Living Streets Aotearoa

Submission to Wellington City Council on Traffic Resolutions TR 01-18 to TR 13-18 re Bus Hubs and Stops, and TR 14-18 Holland St

Contact person: **Mike Mellor**
Email: mmellor1@gmail.com, wellington@livingstreets.org.nz
Phone: **027 684 1213**
Date: **23 February 2018**

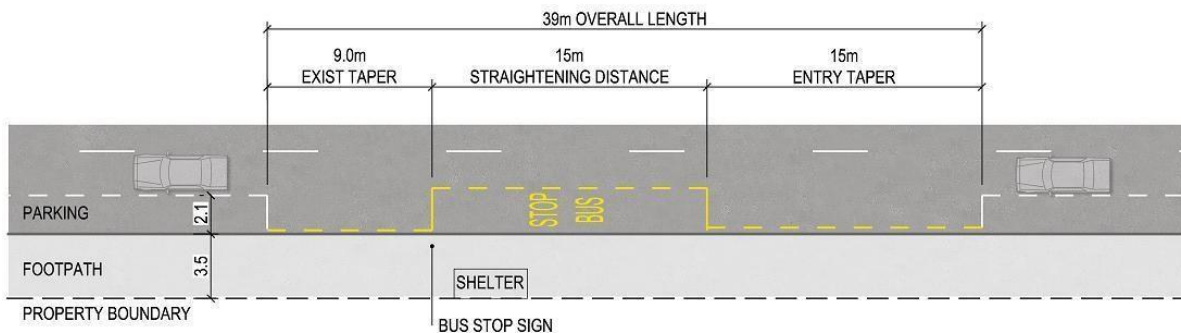
4. We note that not all proposed single bus stop configurations conform with the generally accepted best practice of a 15m box with 15m entry and 9m exit tapers, as below (from <http://nzta.govt.nz/assets/consultation/guidelines-for-public-transport-infrastructure/docs/guidelines-pt-infrastructure-draft.pdf>).

We submit that any departures from such best practice should be identified and explained.
